Docket Item # 2
BAR CASE # 2011-0011

BAR Meeting
April 27, 2011

ISSUE: Request for new construction of 21 townhouse units (17 single-family and 4 triplexes), 3 multi-family buildings and park, and waiver of rooftop screening requirement for Phase IV of the James Bland Redevelopment Project

APPLICANT: Alexandria Redevelopment and Housing Authority by Kenneth Wire (McGuire Woods)

Figure 7. Cornice and HardiePanel details on multi-family buildings.

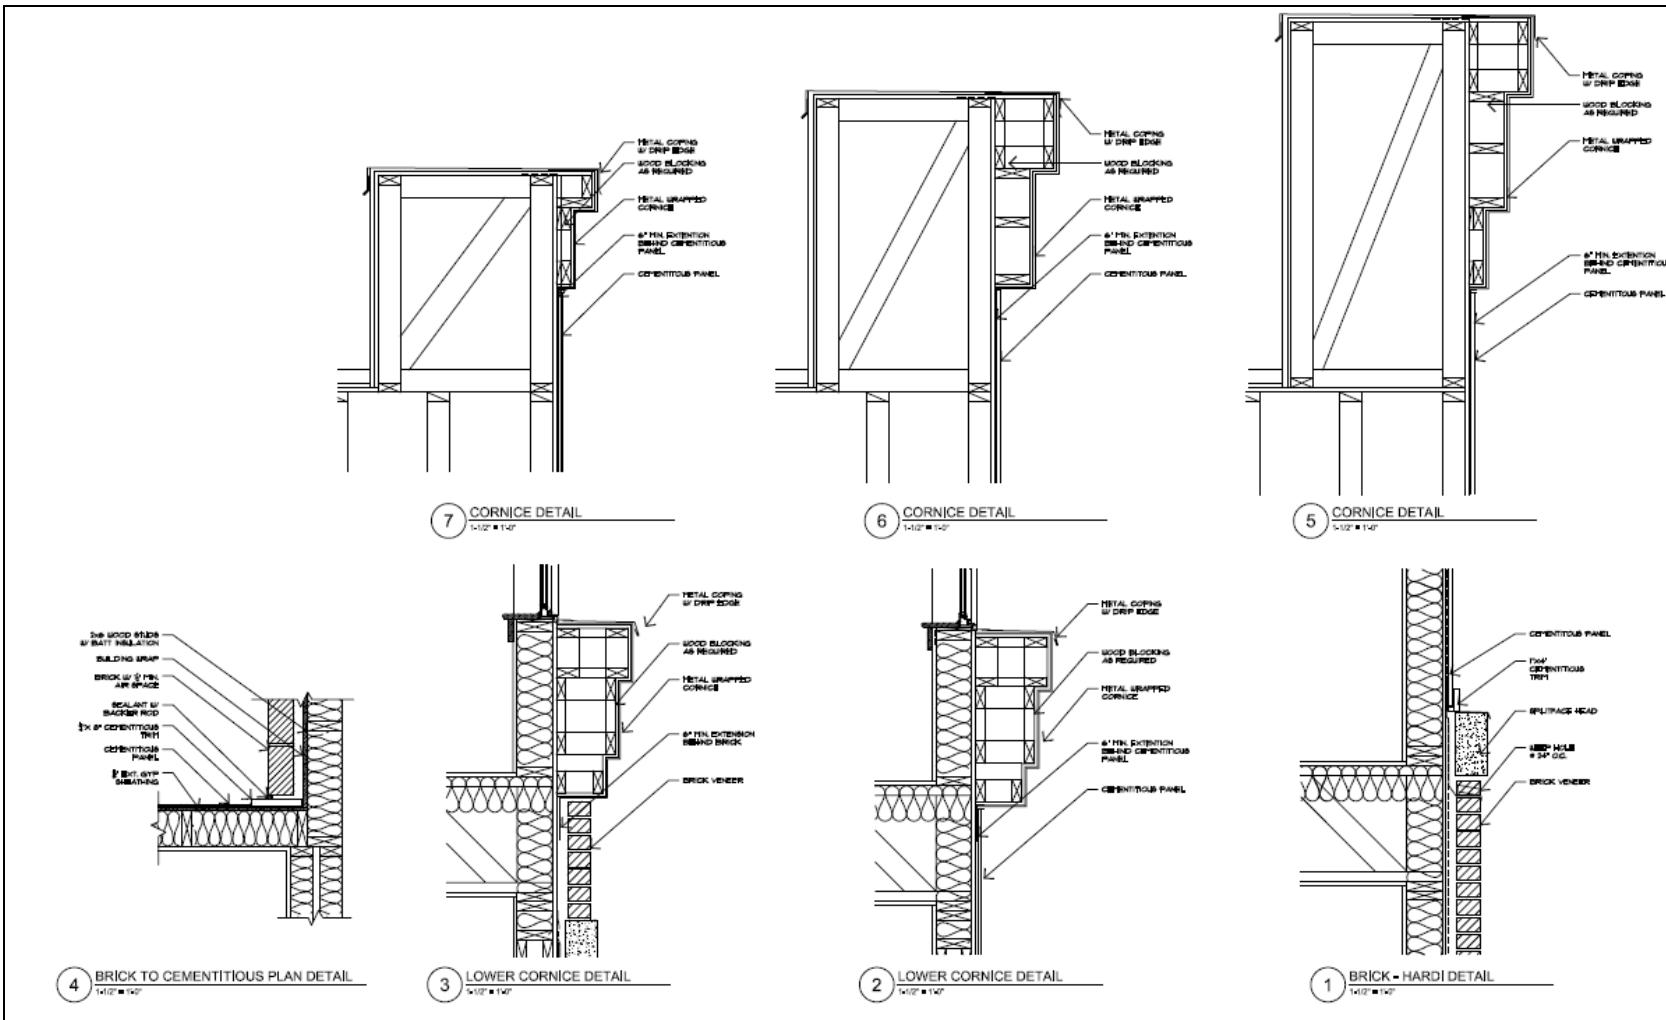
That the applicant consider stucco in place of the HardiePanel.

The applicant continues to propose HardiePanel in a grid form for the fourth floor and building insets. The applicant has provided an example of how this has been used in other projects and a detail of how the HardiePanel will meet the brick wall so that it has a clean appearance. Staff has no objection to the use of HardiePanel in this case. However, Staff notes that the applicant’s drawings indicate a HardiePanel grid proportion above the windows on the fourth story to be rectangular (vertically oriented) in appearance in one scheme and square in other drawings. Staff prefers the square proportion and asks the applicant to clarify this aspect of the grid.

Figure 14. Park Design.

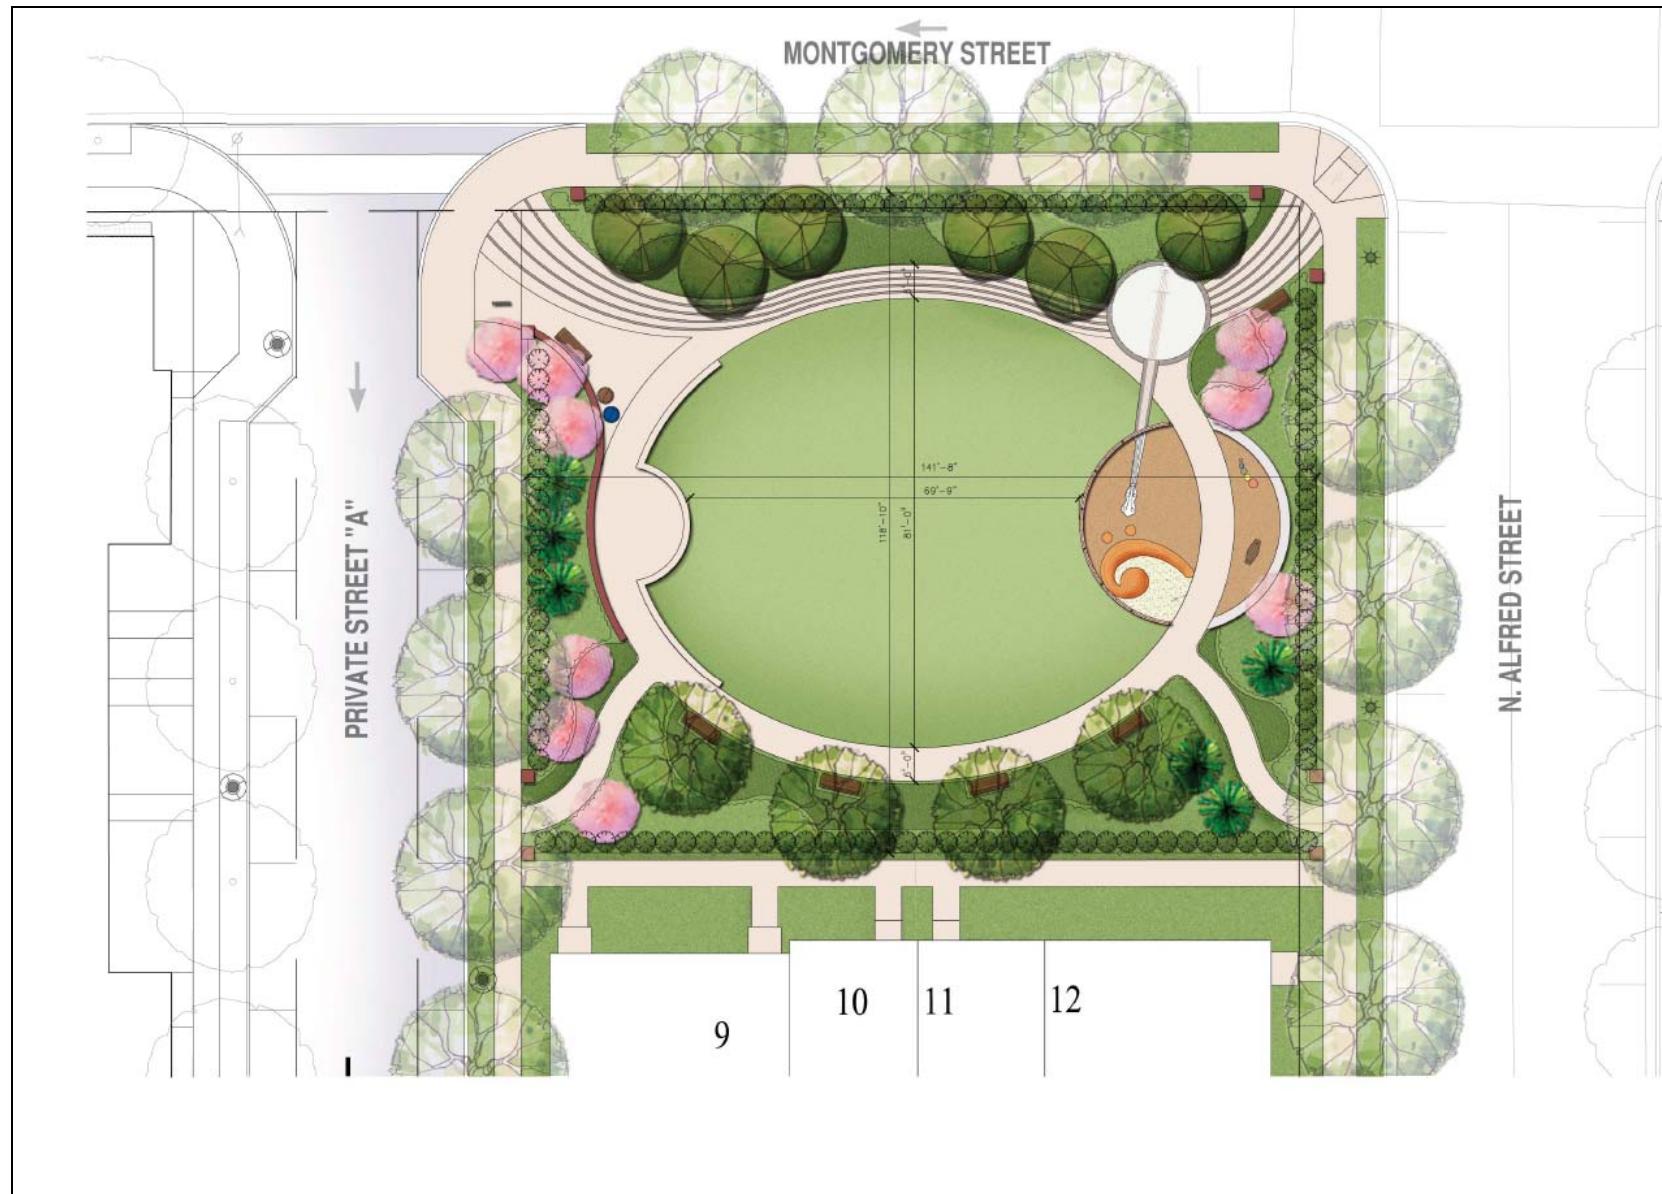
9. That the applicant remove the proposed semi-circular fence adjacent to the play area.

Staff continues to support the conceptual design of the park and believes that the choice of a musically themed park is appropriate as a reference to James Bland, a popular songwriter and musician who was noted for breaking racial barriers in the music industry.¹ Staff has no objection to the majority of the proposed park materials within the Board’s purview, including the open low metal perimeter fence with brick piers and traditional park benches. Staff finds that the semi-circular different low metal fence adjacent to the lawn and play area is not appropriate. The placement of this fence is illogical and the use of a different low metal fence design conflicts with the perimeter fence. After confirming with both Parks and Development Staff that this interior fence is not required, Staff recommends that the fence be omitted.

Figure 15. Proposed mailbox plan.

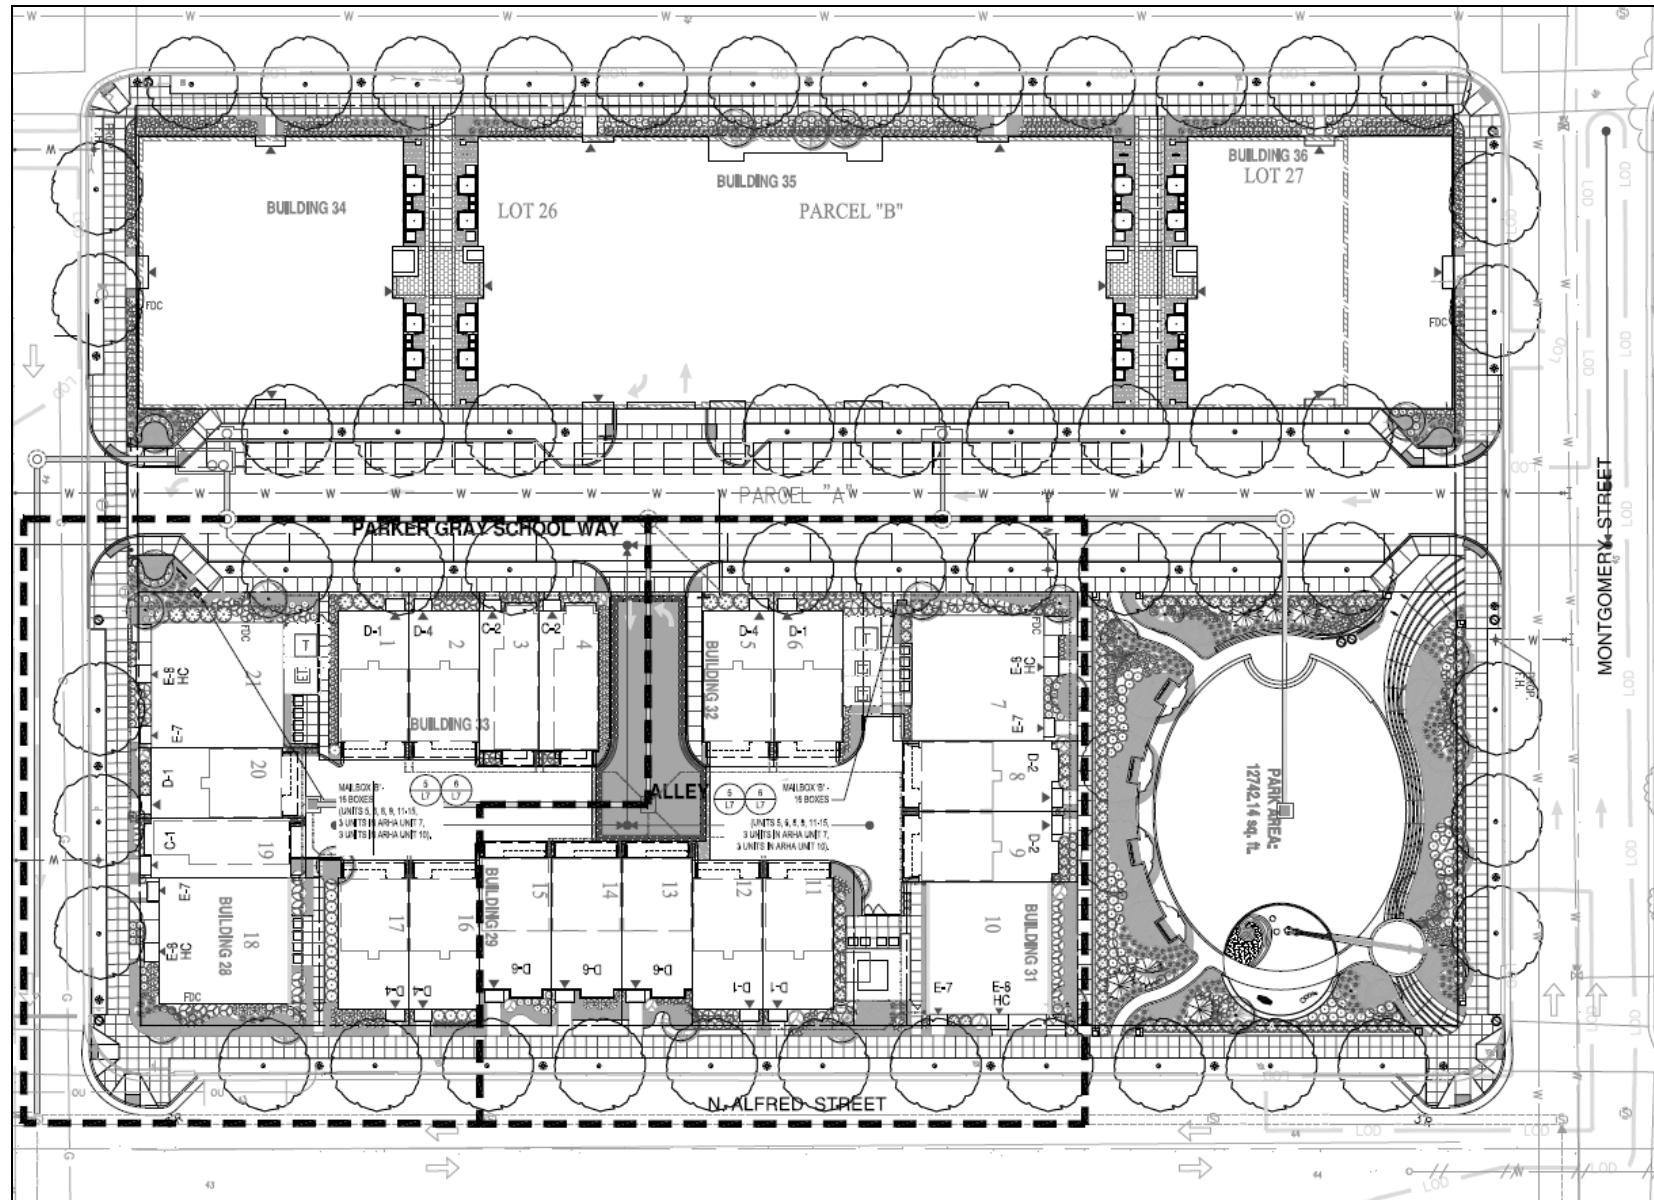
6. That the applicant work with Staff to determine the least obtrusive location for the mail boxes.
7. That the applicant adequately screen all utilities and trash receptacles from the street (public or private). Where illumination is required for utility and trash areas, the light fixtures should be discreet and unobtrusive, with final approval by Staff.
